SUBJECT: PALISADES PLANT - ISSUANCE OF AMENDMENT RE: SPENT FUEL POOL
REGION I STORAGE REQUIREMENTS (TAC NO. ME0161)

AMENDMENT TO RENEWED FACILITY OPERATING LICENSE

Amendment No. 236
License No. DPR-20

SAFETY EVALUATION BY THE OFFICE OF NUCLEAR REACTOR REGULATION

Fuel Loading Pattern for Region 1A

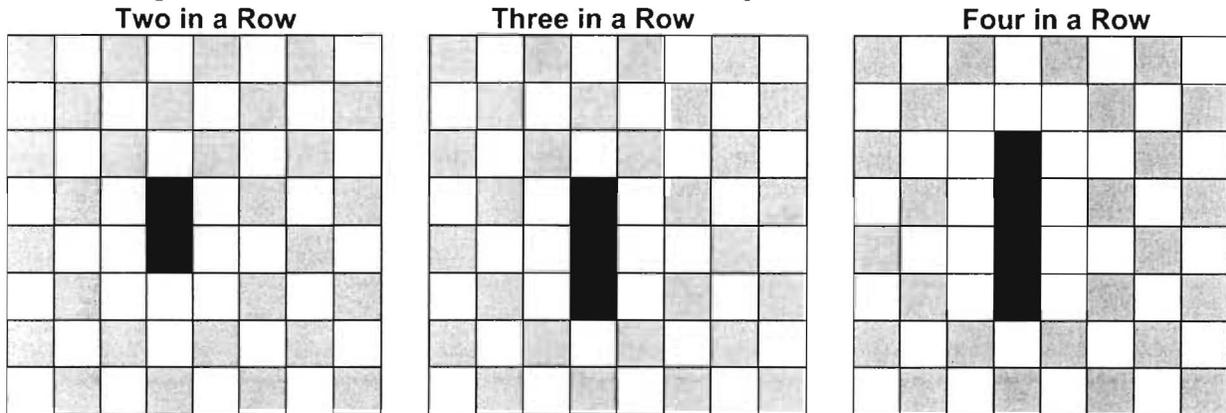
- e. New or irradiated fuel assemblies;
- f. Region 1A is defined as the Region I storage racks located in the main spent fuel pool and are subject to the following restriction. All fuel located in Region 1A shall be in a two-of-four checkerboard loading pattern with empty cells as shown in the figure below. Region 1A fuel is limited to those assemblies having a nominal planar average U-235 enrichment of less than or equal to 4.54 weight percent. Region 1A shall not contain any face adjacent fuel assemblies. Restrictions for non-fissile bearing components are described in section 4.3.1.1j below;

Region 1B Patterns for Three in an L

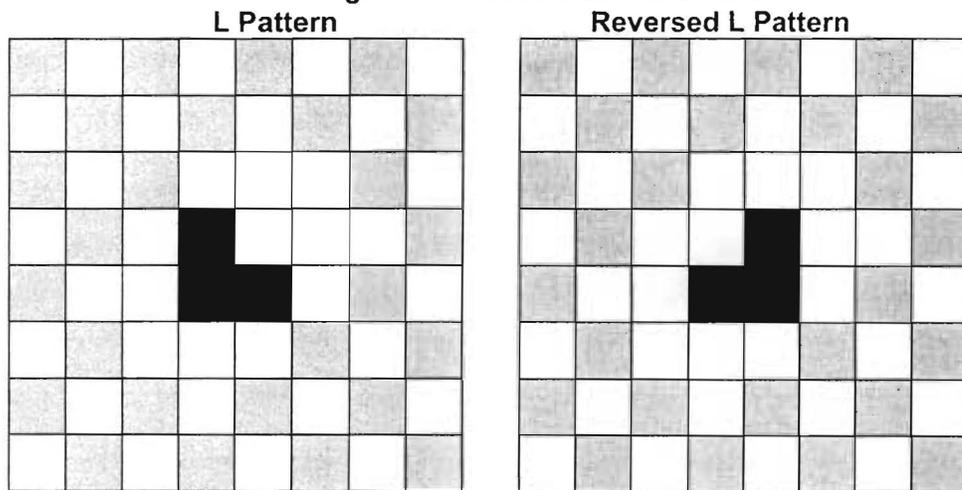
2. Three face adjacent fuel assemblies forming an L pattern are allowed as shown in the figures below. All face adjacent cells surrounding the two-by-two block containing the L pattern shall be empty or contain non-fissile bearing components as described in section 4.3.1.1j below;

Region 1E Allowed Fuel Storage Pattern

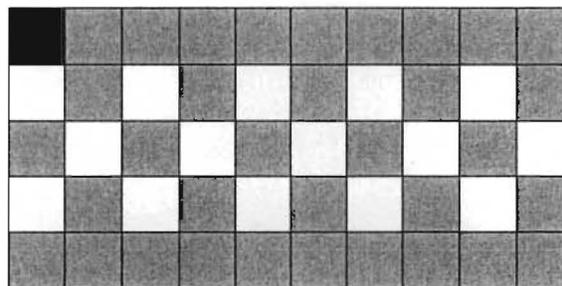
- i. Region 1E is defined as the Region I storage rack located in the north tilt pit. Region 1E shall maintain the selective loading pattern as shown in the figure below. This selective loading pattern allows for one fuel assembly having a nominal planar average U-235 enrichment of less than or equal to 3.26 weight percent. This assembly shall be placed in the southwest corner location of the rack. All 34 other allowed fuel locations in the figure below are limited to a nominal planar average U-235 enrichment of less than or equal to 3.05 weight percent. The remaining fifteen cells shall be empty; and
